MEMORANDUM

SUBJECT: Sunnyside Mine Meeting

RE: Discussion Items for May 17, 1995 Meeting

Settlement Flow Chart  
Sunnyside Gold Corporation

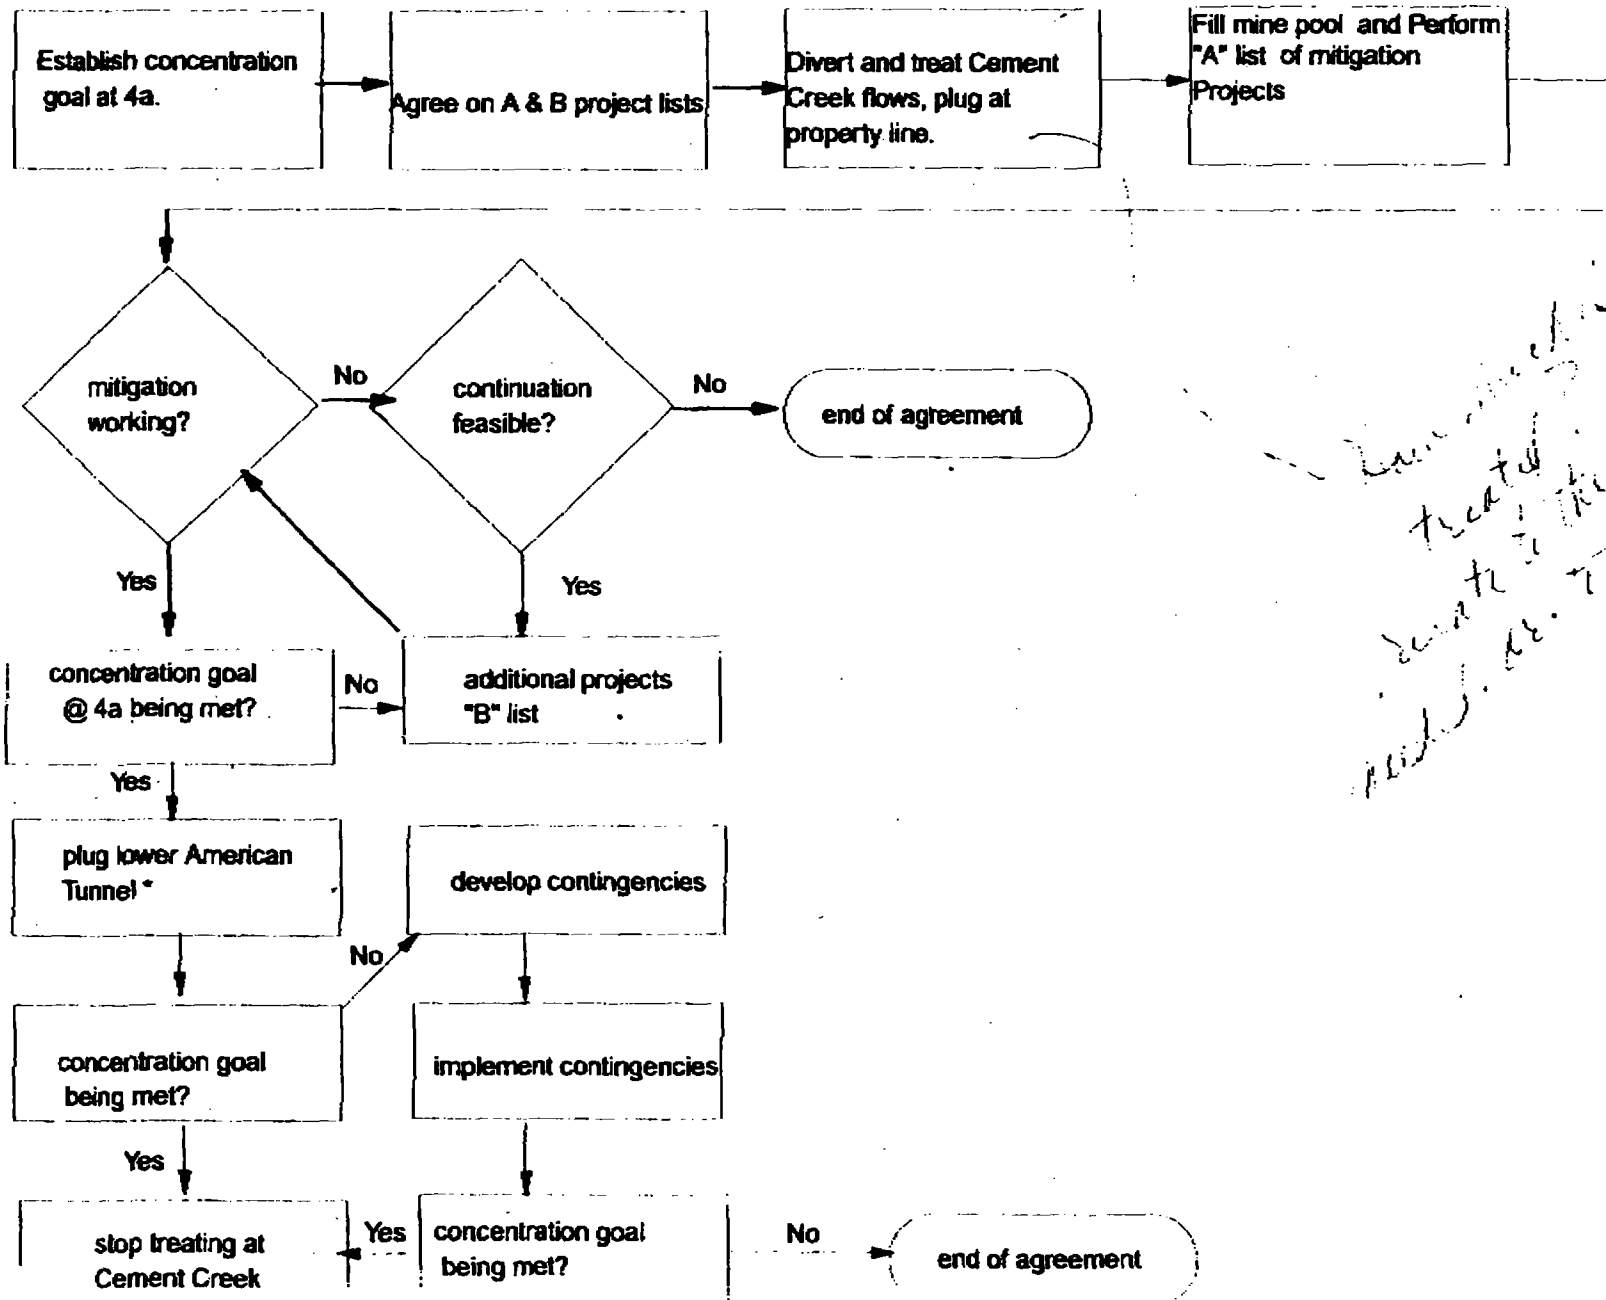
*Handwritten note:*  
 Can we...  
 treated...  
 route to the...  
 mid. dr. the...  
 ...
